WELLS PARK WATERPLAY

5/16/11 PROJECT #568503 May 16 2011

(Wells Park Water Play T.I.)
06/13/2011-201191148
Randy Rudy M.C.P.
Plans Examiner
(505) 924-3961
rrudy@cabq.gov
www.cabq.gov
PLAN EXAMINERS AVAILABLE MONDAY THRU FRIDAY 08:30 TO 11:30

TITLE: WELLS PARK WATERPLAY
UTILITY PLAN

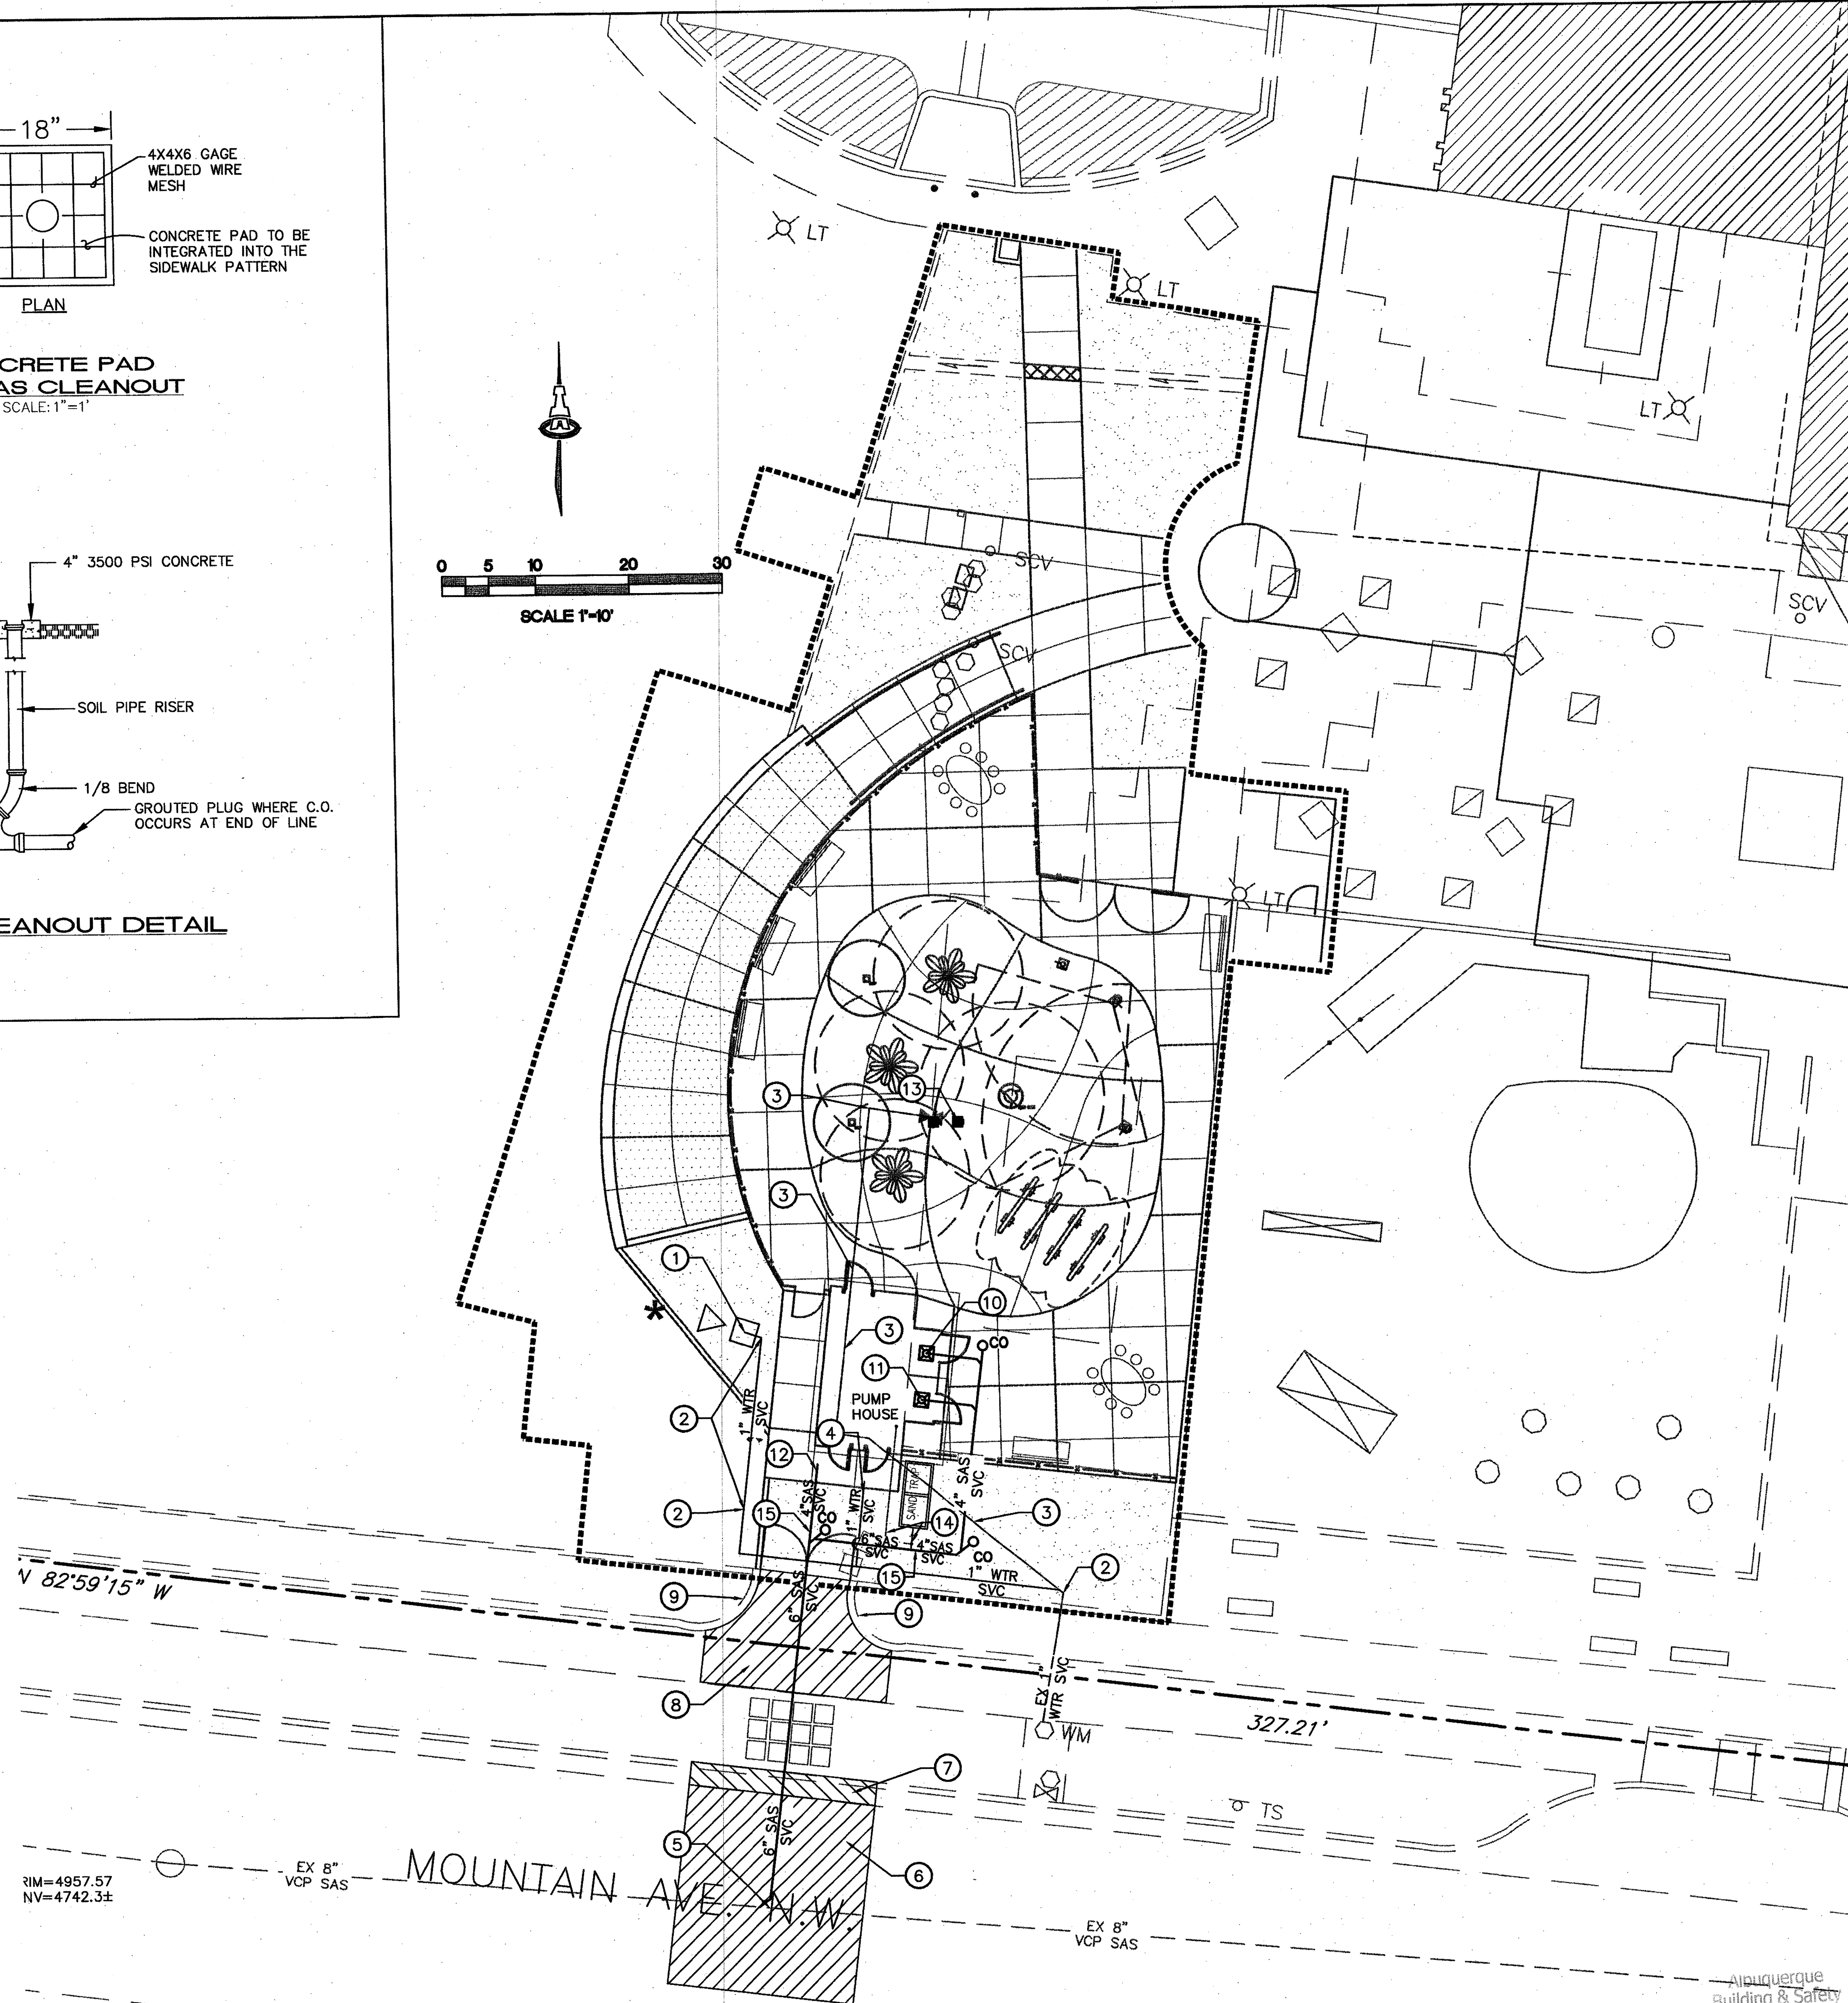
3. Sheet 6 of 18. Please submit chemical compatibility chart for drain pipe and chemicals used as per 06 UPC Section 101.3.
 4. Sheet 6 of 18. Please submit water features water/drain pipe specifications as per 06 UPC Section 101.3.

I'm thinking that if I specify PVC for the sewer services on the plans, that may cover the reviewer's concerns. Do you have his contact info so I can call or email him to see if he's OK with that?

C1 DOOR & FRAME TYPES
1/4" = 1'-0"

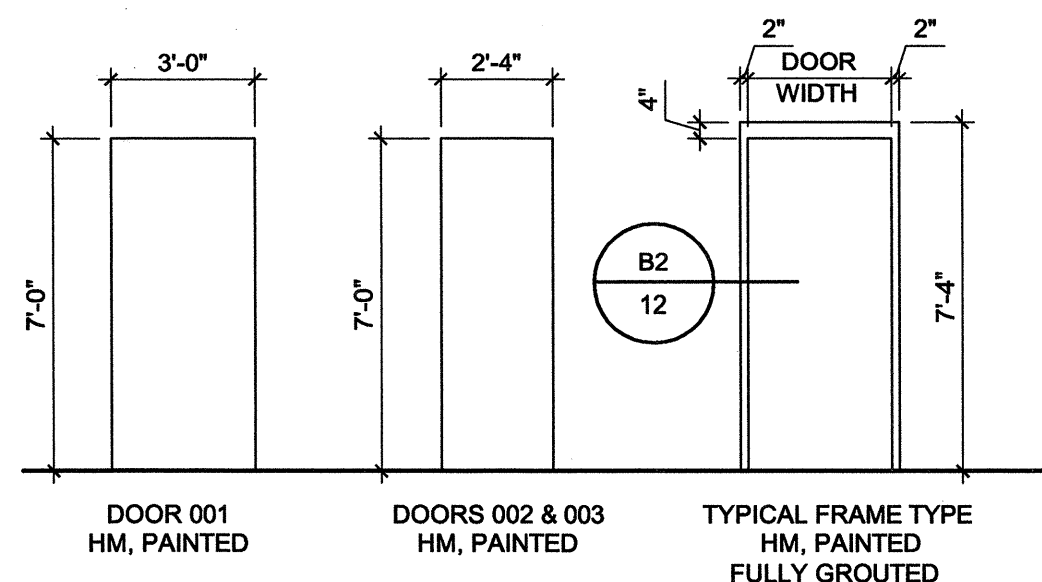
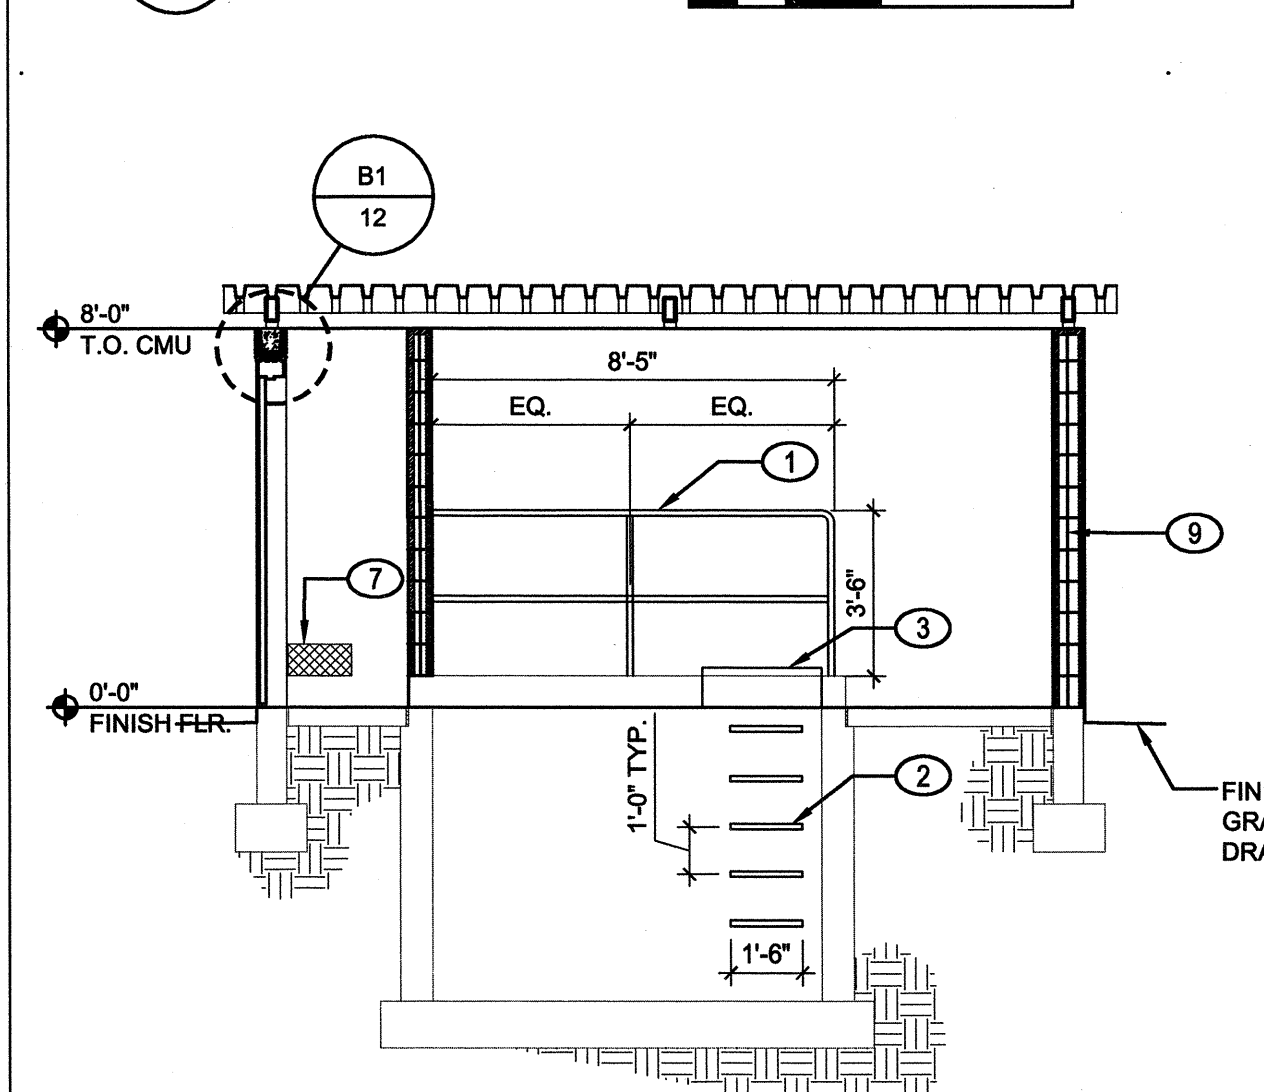
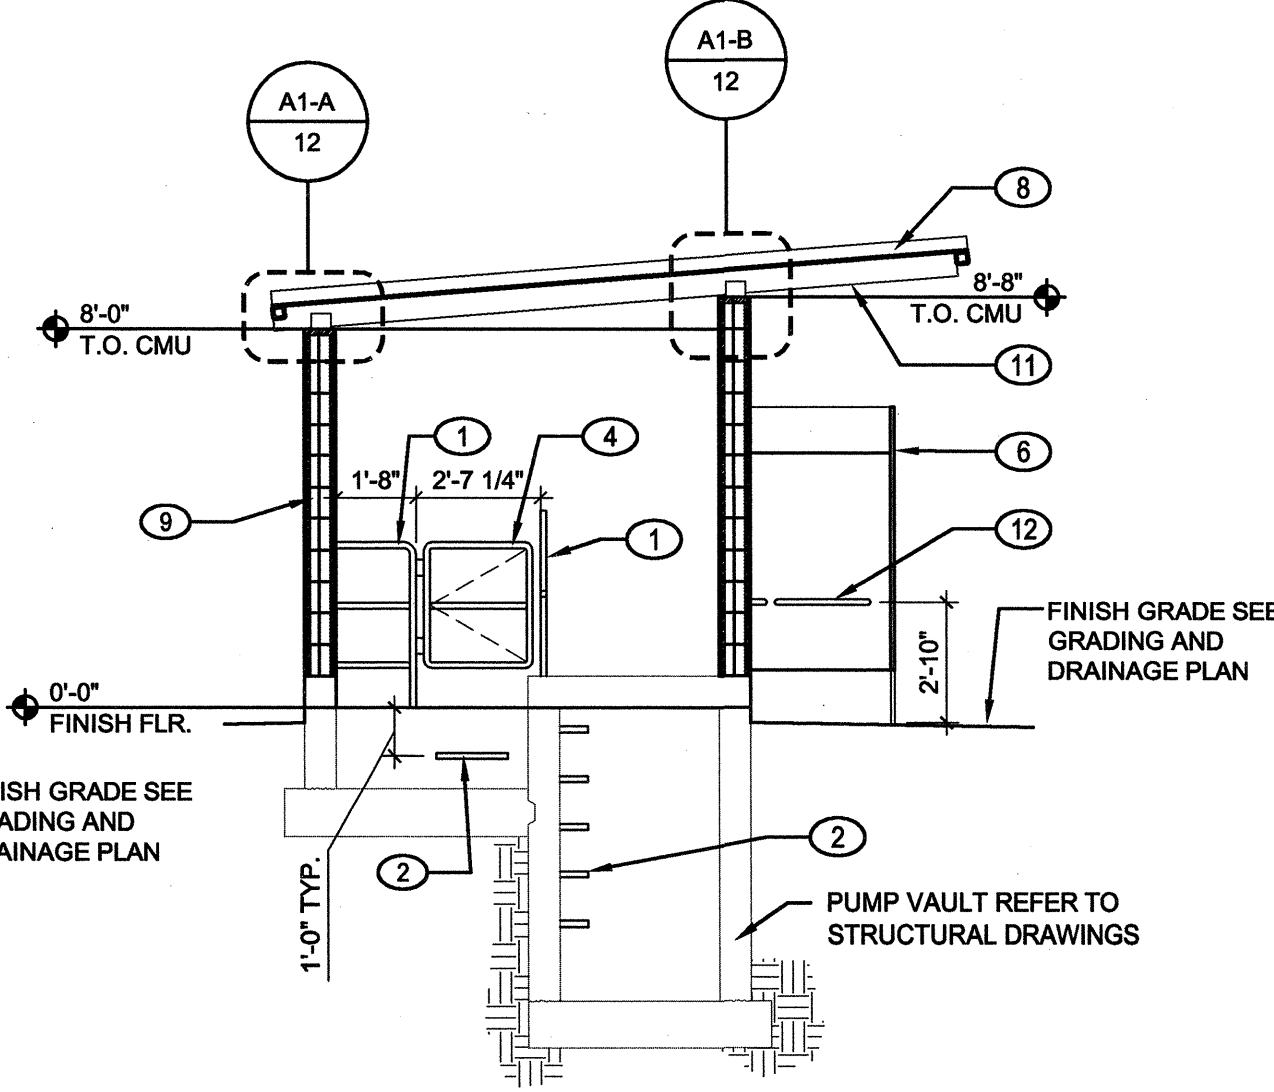
- UMC
1. Sheet 12 of 18. Please detail D1 and C3; ventilation for chlorine/acid room storage shall be in accordance with 2003 IFC Section 2704.3 as per 06 UPC Section 101.3.

2. Sheet 13 of 18. Please provide minimum performance of water heater as per 06 IECC Table 504.2.
- UPC
1. Sheet 12 of 18. Detail C3; please specify storage amounts of chlorine & acid as per 03 IFC Table 2703.1.1 (2) and Chapter 31.

2. Sheet 12 of 18. Chlorine/acid storage shall require secondary containment when the capacity of an individual vessel exceeds 55 gallons or the aggregate capacity of multiple vessels exceeds 1,000 gallons as per 03 IFC Section 2704.2.2 & Table 2704.2.2 and contained in accordance with 2704.2.2.1.
